APPLICATION NO.	FILING	DATE	FIRST NAMED INVENTOR	ATTORNEY DOCKET NO.	CONFIRMATION NO.
10/081,273		02/21/2002		Edward C. Carman JR.	843P010811-US (PAR)	9776
	2512	2512 7590 03/17/2006			EXAMINER	
	PERMAN &			PHAM, HUONG Q		
	425 POST RO			ART UNIT	PAPER NUMBER	
	FAIRFIELD,	C1 00824	•		3764	
				DATE MAILED: 03/17/2006

Application No.	Applicant(s)						
Office Action Summans	10/081,273	CARMAN ET AL.						
Office Action Summary	Examiner	Art Unit						
	Huong Q. Pham	3764						
The MAILING DATE of this communication appears on the cover sheet with the correspondence address Period for Reply								
A SHORTENED STATUTORY PERIOD FOR REPLY IS SET TO EXPIRE 3 MONTH(S) OR THIRTY (30) DAYS, WHICHEVER IS LONGER, FROM THE MAILING DATE OF THIS COMMUNICATION. - Extensions of time may be available under the provisions of 37 CFR 1.136(a). In no event, however, may a reply be timely filled after SIX (6) MONTHS from the mailing date of this communication. - If NO period for reply is specified above, the maximum statutory period will apply and will expire SIX (6) MONTHS from the mailing date of this communication. - Failure to reply within the set or extended period for reply will, by statute, cause

FIG._4

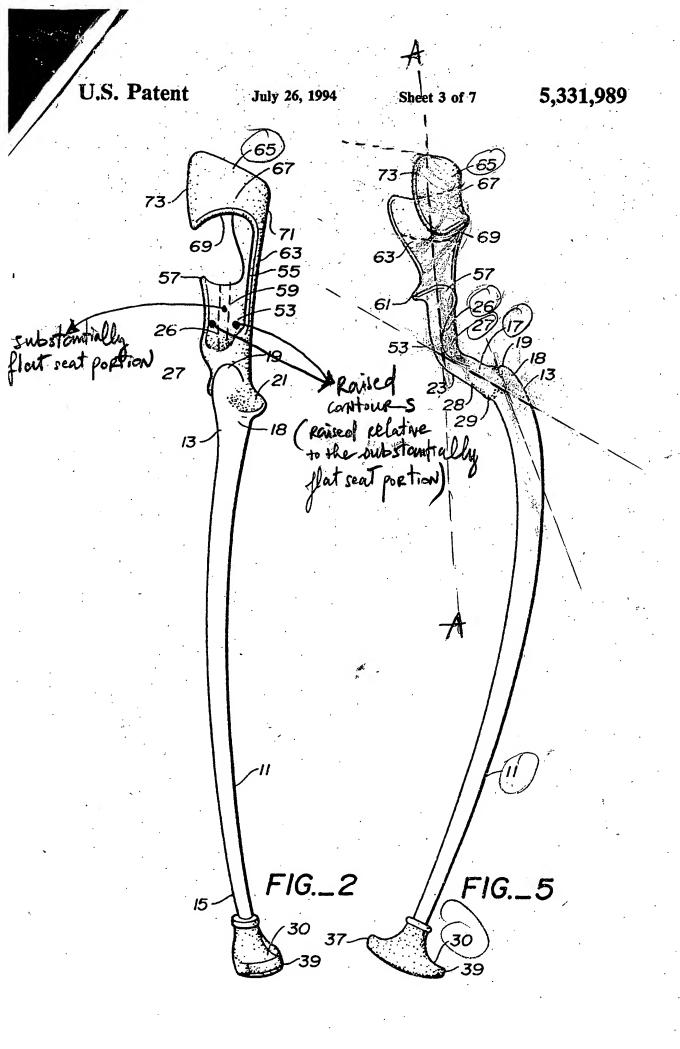
In response to applicant 's argument on page 22 that "The figures are clearly drawn in a perspective view looking slightly upward in figures 2 and 5 and slightly downward in figures 3 and 4.", note that on column 2, Stephens mentioned that figures 2-5 are elevational views (not perspective views). Therefore these views are at 90 degree side views of the device. There is no slight up angle or slight down angle views. If these drawings were drawn at angle as applicant suggests, Stephens would have referred to these drawings as perspective views.

the whole disclosure of the patent to Stephens, which includes the specification, the drawings, and the claims. Note that the reference does not have to exactly mention the word" helix" or "spiral", figures 2-5 clearly teach this helix (note attached drawings).

raised contour. The flat seat portion of Stephens extends along a plane defined by the line A-A as noted in figure 5 of the attached drawings.
